Product Change Notice (PCN)

Subject: Add tray and desiccant for RX Family • RA Family/RA4 Series LQFP/LFQFP.

RX Family · RA Family/RA4 Series Difference specification

(LQFP/LFQFP_ Add type of tray and desiccant)
7x7mm, 10x10mm, 12x12mm, 14x14mm

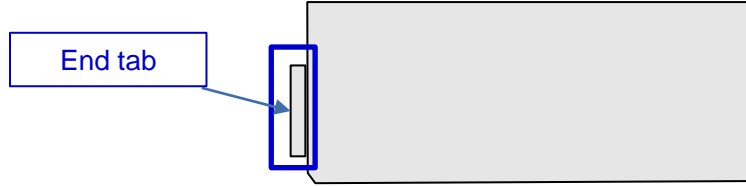
- ✓ Add a type of desiccant.
 - There is no change in the storage conditions.
